Access Compliance Report

Public Rights-of-Way

Intersection ID: 20326	Main Street: MONTPELIER_RD	Cross Street: WEDGEDALE_DR	Location:	N
ADA ID: 15336118FB61	Ramp Type: BlendTrans2	Initial Pass/Fail: Pass	Overall Compliance: No	Severity Score: 2.75
Codes/Mitigation Info/Possible Solution		Field Measurements/Component Compliance

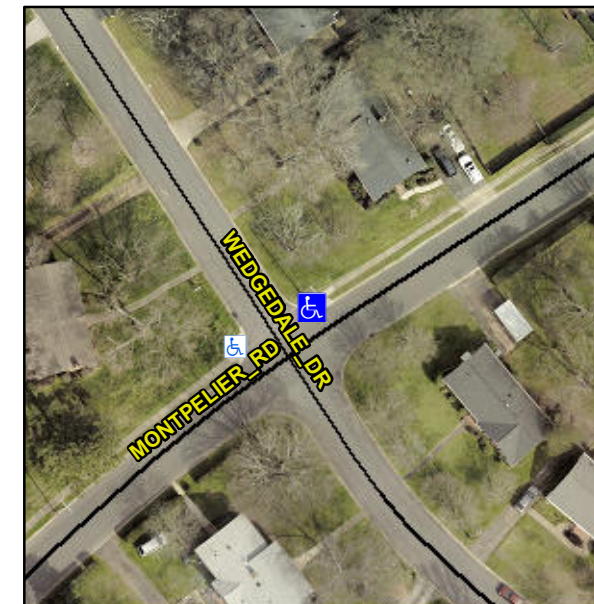
ASP LIP 1.0

R304.5.3, R305.1.4, R305.2

Remove & Replace Curb Ramp With Two New Directional Ramps or Equivalent. Remove & Replace Gutter.
